# Customer Service Notice

Units Affected: All AT40M/P units built from serial numbers 0607CZ0000 (June, 2007) through 1009CZ0118 (October, 2009)

## Link Replacement

Figure 1 — Link Location

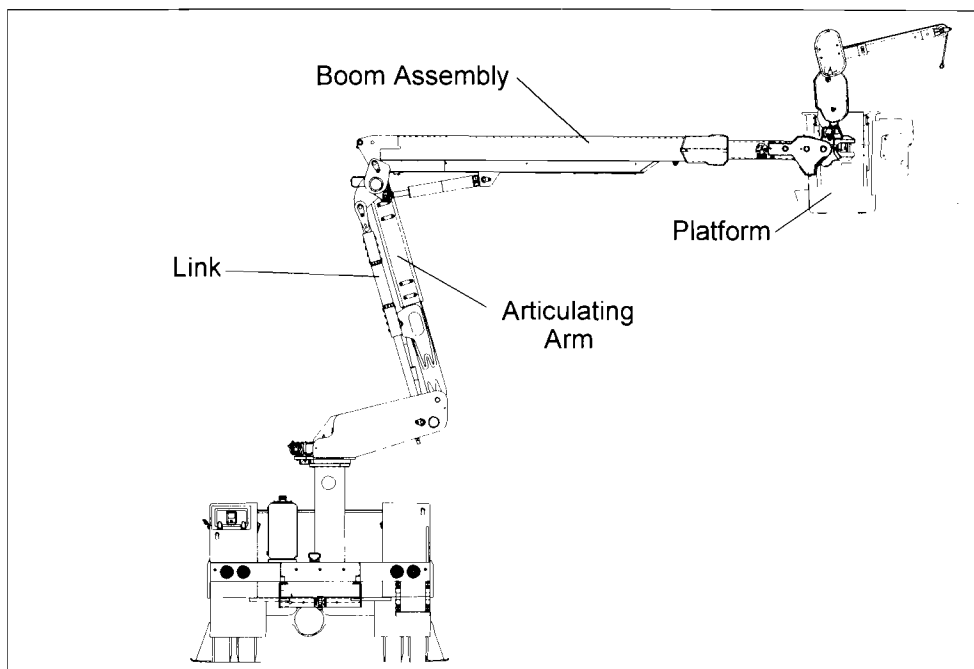
The link on the AT40M/P units is part of the articulating arm assembly (refer to Figure 1). The link is also part of the chassis insulating system on the aerial device. Altec has found rust inside the steel weldment may run over the inner surface of the insulating link and over time compromise the dielectric integrity of the link. The source of the rust within links was found to be metal particles generated during manufacturing. This condition only effects the quality of the insulating link of the chassis insulating system. The chassis insulating system is not required by industry standards, but was provided by Altec as standard equipment on these units. The insulating properties of the main boom are not effected.

Altec requires that the links on the above listed units be replaced to ensure continued dielectric integrity. The links must be replaced within 60 days of receipt of this CSN. If the chassis insulating system has been dielectrically tested within the last year, the unit may continue to be operated as normal while awaiting link replacement. If the unit has not had the chassis insulating system tested in the last year, such a test should be conducted or crews must treat the link sections as non-insulating. The manufacturing process has been changed and replacement link has been redesigned to address the initial condition.

Call 1-877-GO-ALTEC to order the Link Replacement Kit, part number 970299534, or to schedule the work to be done by an Altec service technician. This repair is covered under the Altec Warranty System. Installation of the Link Replacement Kit can be done by the customer. The parts for this repair are covered under the Altec Warranty System. Additionally, Altec will reimburse up to \$240 for the labor to perform this repair. A warranty claim must be submitted for reimbursement for the cost of the parts and labor. Customers are responsible for the travel costs of an Altec Mobile Service technician if the technician performs the repair at the owner's location.
